Access Compliance Report

Public Rights-of-Way

(Curb Ramps)

Intersection ID: 9284	Main Street: HARRISON_ST	Cross Street: N/A	Location:	N
ADA ID: ADDA931C77AA	Ramp Type: Perp	Initial Pass/Fail: Fail	Overall Compliance: No	Severity Score: 22.5
Codes/Mitigation Info/Possible Solution		Field Measurements/Component Compliance

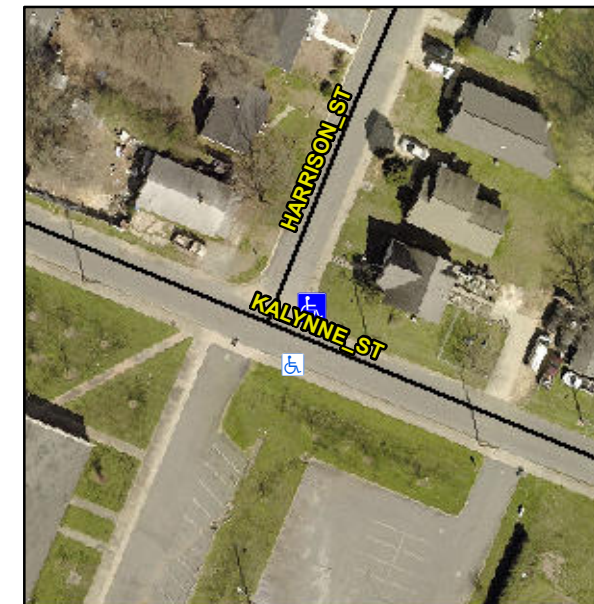
Not Found, R304.5.1, R304.2.2, R304.5.3

Compliance	Description	Data	Compliance	Description	Data
N/A	Ramp Length (in)	44.0	No	Ramp Slope (%)	9.8
No	Ramp Width (in)	46.0	No	Ramp XSlope (%)	4.0
N/A	Flare Type LT	N/A	N/A	Flare Type RT	N/A
N/A	Flare Slope LT (%)	N/A	N/A	Flare Slope RT (%)	N/A
N/A	Flare Traversable LT?	N/A	N/A	Flare Traversable RT?	N/A
N/A	Landing Length (in)	N/A	N/A	DWS Provided?	N/A
N/A	Landing Width (in)	N/A	N/A	DWS Contrast?	N/A
N/A	Landing Slope (%)	N/A	N/A	DWS Length (in)	N/A
N/A	Landing X Slope (%)	N/A	N/A	DWS Full Width?	N/A
N/A	Landing Curb? (Y/N)	N/A	N/A	DWS Offset (in)	N/A
N/A	Shared Landing?	N/A			
N/A	Gutter Ponding?	N/A	N/A	Gutter Slope (%)	N/A
N/A	Gutter Lip Ht (in)	N/A	N/A	Gutter X Slope (%)	N/A
N/A	Painted X Walk1?	No	N/A	Painted X Walk2?	N/A
	X Walk 1 Direction	To S		X Walk 2 Direction	N/A
N/A	X Walk 1 Width (in)	N/A	N/A	X Walk 2 Width (in)	N/A
	X Walk 1 Slope (%)	3.6		X Walk 2 Slope (%)	N/A
	X Walk 1 X Slope (%)	1.5		X Walk 2 X Slope (%)	N/A

Remove & Replace Entire Ramp.
